Access Compliance Report

Public Rights-of-Way

(Curb Ramps)

Intersection ID: 43493	Main Street: BIRCHFIELD_CT	Cross Street: CHESLEY_DR	Location: NW
ADA ID: 7A0A43C81C4C	Ramp Type: PerpDiag	Initial Pass/Fail: Fail	Overall Compliance: No
Severity Score: 33.75			
Codes/Mitigation Info/Possible Solution		Field Measurements/Component Compliance

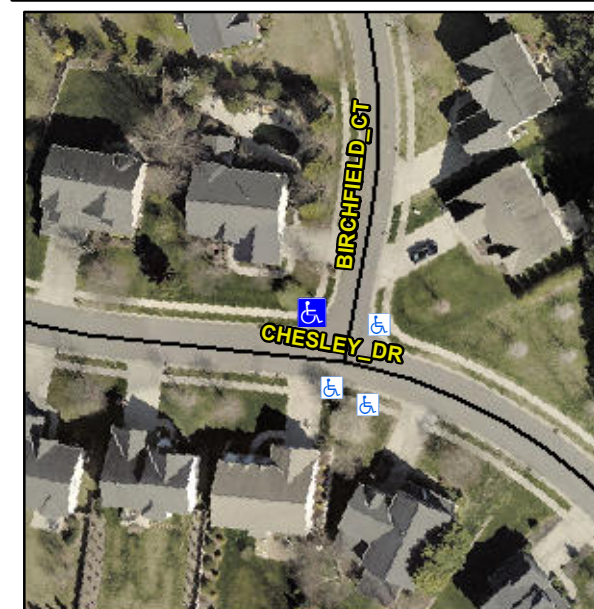
Not Found, R304.5.1, R304.5.3

Compliance	Description	Data	Compliance	Description	Data
N/A	Ramp Length (in)	47.0	Yes	Ramp Slope (%)	6.7
No	Ramp Width (in)	37.0	No	Ramp XSlope (%)	8.7
N/A	Flare Type LT	N/A	N/A	Flare Type RT	N/A
N/A	Flare Slope LT (%)	N/A	N/A	Flare Slope RT (%)	N/A
N/A	Flare Traversable LT?	N/A	N/A	Flare Traversable RT?	N/A
N/A	Landing Length (in)	N/A	N/A	DWS Provided?	N/A
N/A	Landing Width (in)	N/A	N/A	DWS Contrast?	N/A
N/A	Landing Slope (%)	N/A	N/A	DWS Length (in)	N/A
N/A	Landing X Slope (%)	N/A	N/A	DWS Full Width?	N/A
N/A	Landing Curb? (Y/N)	N/A	N/A	DWS Offset (in)	N/A
N/A	Shared Landing?	N/A			
N/A	Gutter Ponding?	N/A	N/A	Gutter Slope (%)	N/A
N/A	Gutter Lip Ht (in)	N/A	N/A	Gutter X Slope (%)	N/A
N/A	Painted X Walk1?	No	N/A	Painted X Walk2?	No
	X Walk 1 Direction	To S		X Walk 2 Direction	To SE
N/A	X Walk 1 Width (in)	N/A	N/A	X Walk 2 Width (in)	N/A
	X Walk 1 Slope (%)	4.3		X Walk 2 Slope (%)	2.6
	X Walk 1 X Slope (%)	4.7		X Walk 2 X Slope (%)	3.6

Remove & Replace Curb Ramp With Two New Directional Ramps or Equivalent.
